| Project | IEEE 802.16 Broadband Wireless Access Working Group < http://ieee802.org/16 > | |
| Title | Comments on CDMA BR ranging in the MR system | |
| Abstract | This contribution proposes modification on SS CDMA BR ranging in the MR system | |
| Purpose | Text proposal for 802.16j Draft Document. | |

Figure X—BW request/allocation signaling for transparent RS

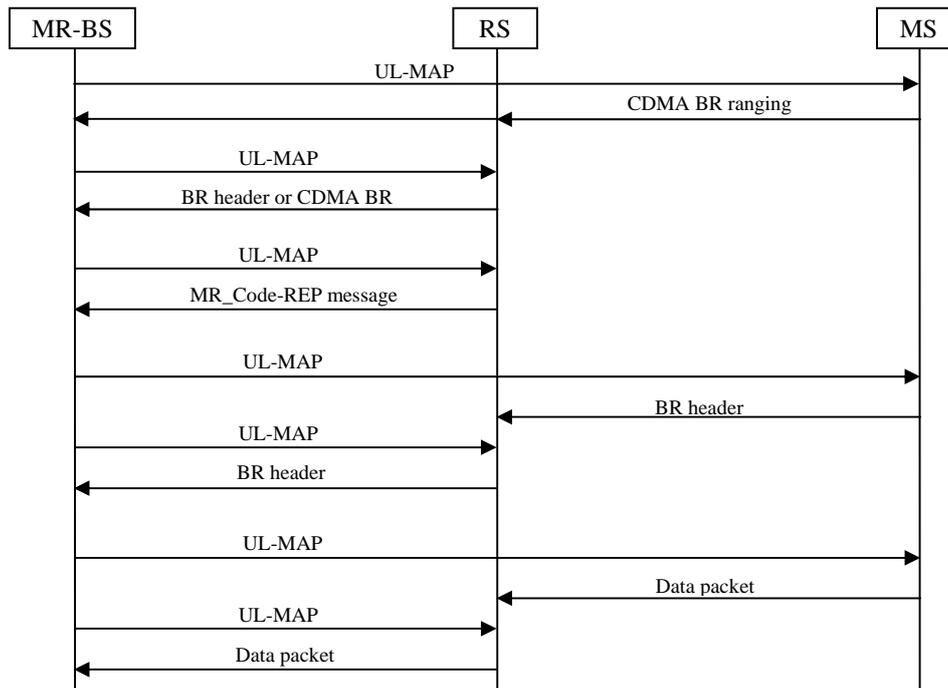
~~When a transparent RS receives overhears a one or more bandwidth request CDMA ranging codes from a subordinate station, it shall forward an MR-Code-REP message to the MR-BS. The MR-Code-REP contains the CDMA ranging code that was sent by the SS as well as its transmit region and channel adjustment information. If the transparent RS receives more than one bandwidth request CDMA ranging code from its subordinate SSs within one frame, it shall forward as many codes as possible (along with their transmit regions and channel adjustment information) within the MR-Code-REP message based on the available uplink bandwidth. If there is not enough bandwidth for all code information, the RS shall indicate in the MR-Code-REP message the **number size** of remaining codes to be reported. Based on this number, the MR-BS can allocate uplink bandwidth for the remaining code information. Using the code and transmit region information the MR-BS shall generate the appropriate CDMA-Allocation-IEs that prompt the SSs to forward their bandwidth request headers on the access uplink. If management messages are relayed on the uplink, the MR-BS shall insert an UL-Burst-Receive-IE in front of the CDMA-Allocation-IE in the UL-MAP. The UL-Burst-Receive-IE shall contain either the RS basic CID of the assigned RS or the multicast management CID. The MR-BS shall also create bandwidth allocations along the relay path from the assigned RS for the purpose of forwarding these SS bandwidth request headers to the MR-BS (see Figure X 60a).~~

Figure X—BW request/allocation signaling for transparent RS

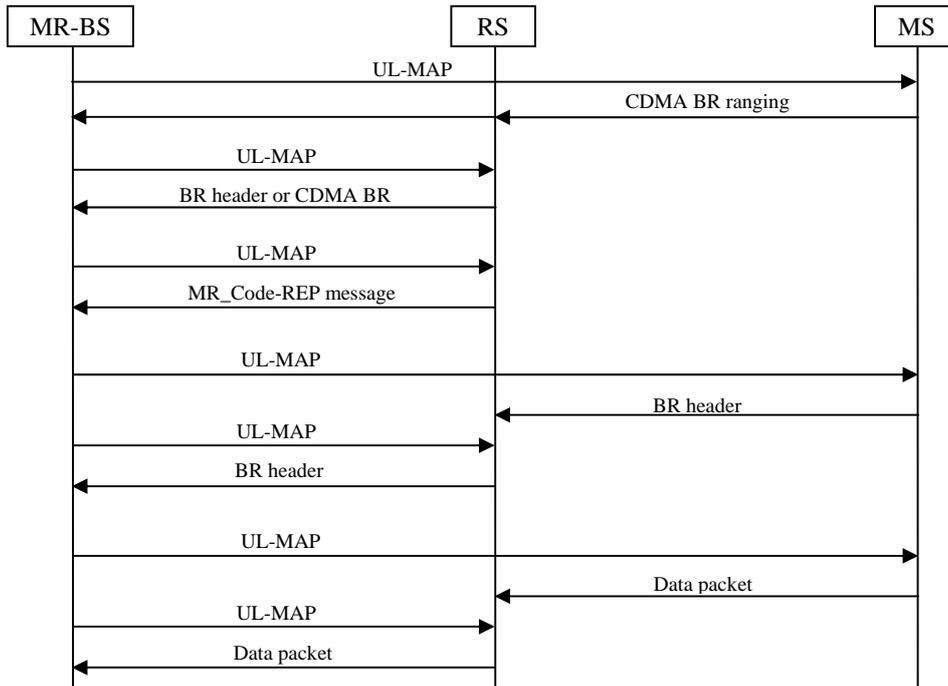
When a transparent RS overhears one or more bandwidth request CDMA ranging codes from its subordinate SSs within one frame, it shall forward as many codes as possible along with their transmit regions and channel adjustment information within the MR Code-REP message based on the available uplink bandwidth. If there is not enough bandwidth for all code information, the RS shall indicate in the MR Code-REP message the size of remaining codes to be reported. Based on this number, the MR-BS can allocate uplink bandwidth for the remaining code information. Using the code and transmit region information the MR-BS shall generate the appropriate CDMA Allocation IEs that prompt the SSs to forward their bandwidth request headers on the access uplink. If management messages are relayed on the uplink, the MR-BS shall insert an UL Burst Receive IE in front of the CDMA Allocation IE in the UL-MAP. The UL Burst Receive IE shall contain either the RS basic CID of the assigned RS or the multicast management CID. The MR-BS shall also create bandwidth allocations along the relay path from the assigned RS for the purpose of forwarding these SS bandwidth request headers to the MR-BS (see Figure X).
